H. B. ROBINSON STEAM ELECTRIC PLANT, UNIT NO. 2
DOCKET NO. 50-261/LICENSE NO. DPR-23

**RESPONSE TO REQUEST FOR ADDITIONAL INFORMATION ON
TECHNICAL SPECIFICATIONS CHANGE REGARDING INOPERABLE
ANALOG ROD POSITION INDICATION FOR CONTROL ROD H-10 (TAC NO. MB7265)**

Figure 1. Simplified Diagram of ARPI Channel.

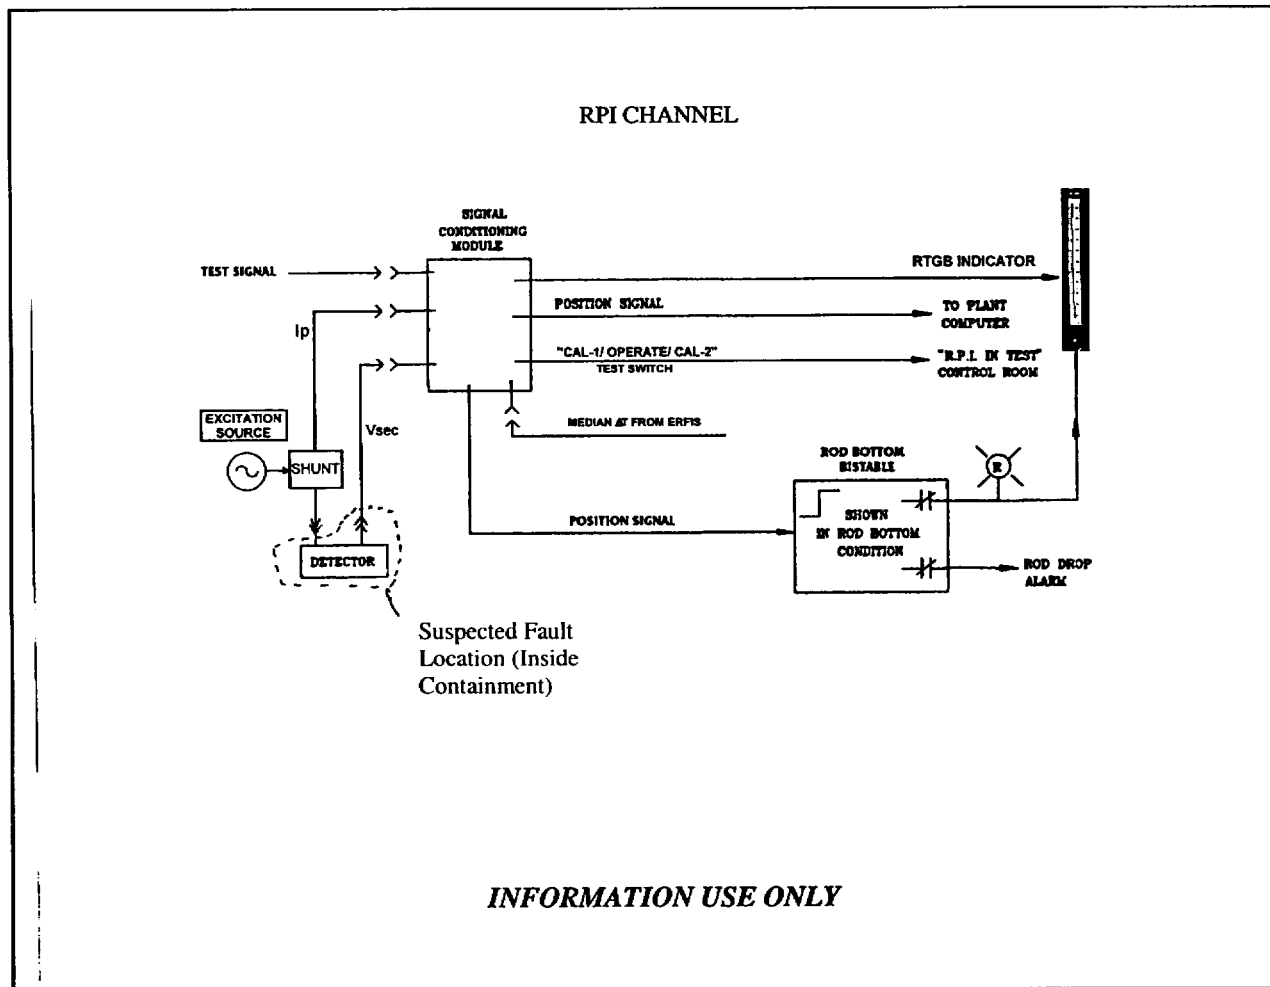
5. The licensee has concluded that the fault in the ARPI for Control Rod H-10 has occurred near the reactor vessel. The ARPI system provides input to alarms and additional instrumentation systems. The staff requests the licensee provide a one-line diagram of the ARPI system for Control Rod H-10. This diagram should identify the suspected fault location, the affected alarms, relays, or interlocks that receive input from the system, and a description of how the fault will affect their operation. For any affected alarms, relays, or interlocks, the staff requests the licensee describe compensatory measures that will be used to offset the loss of these features.

A simplified diagram of the RPI channel is provided as Figure 1. The fault is believed to be in the cable connector at the top of the ARPI detector or in the ARPI detector itself. The affected alarms/functions are the rod bottom indicator for Control Rod H-10, the rod misalignment alarm for Control Rod H-10, and the rod drop alarm for Control Rod H-10. The January 16, 2003, license amendment request states the following:

The HBRSEP, Unit No. 2, TS require that the position of a control rod with an inoperable ARPI be verified by the use of the movable incore detector system once per 8 hours, in accordance with TS 3.1.7, Required Action A.1. The proposed license amendment request provides an alternate means for accomplishing this required verification. The alarms/functions associated with the ARPI that are not available are not affected by the use of alternate means of verification. The proposed alternate monitoring method provides an additional method for detection of a possible deviation of Control Rod H-10 from the required position. No additional compensatory measures are required for the alarms/functions that are not available.
